ABS Solenoid Valve with Adapter Cable in a Set

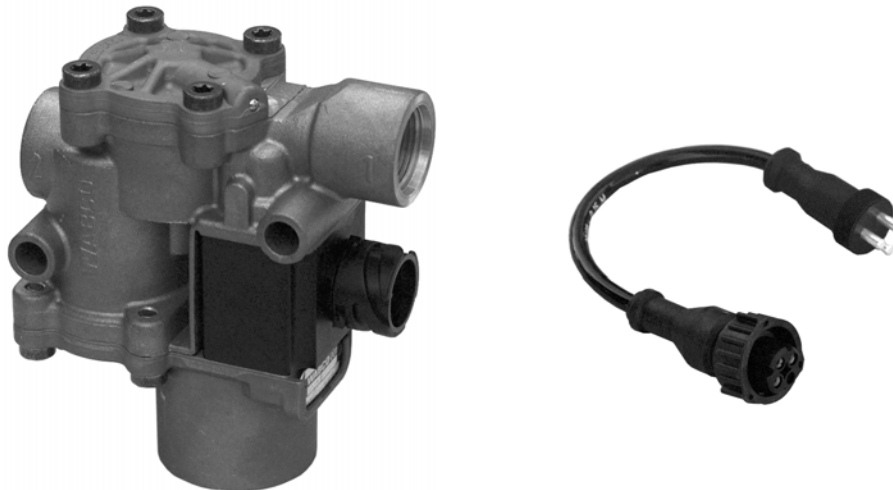
As announced some times ago, WABCO in future will distribute ABS solenoid valves no longer with Kostal connector but with DIN bayonet.

The change-over of vehicles in the market will take some time. New trailer are fitted solely with devices and cables having DIN bayonets.

When replacing failed ABS solenoid valves, we recommend to replace cables aswell. Alternatively you need an additional adapter cable which can be ordered under 894 601 132 2 from your WABCO partner.

For an intervening period, we offer two devices for the aftermarket together with the adapter cable in a set:

472 195 004 0 / 7 replaced by **472 195 921 2** (472 195 018 0 + 894 601 132 2)

472 195 008 0 / 7 replaced by **472 195 920 2** (472 195 016 0 + 894 601 132 2)
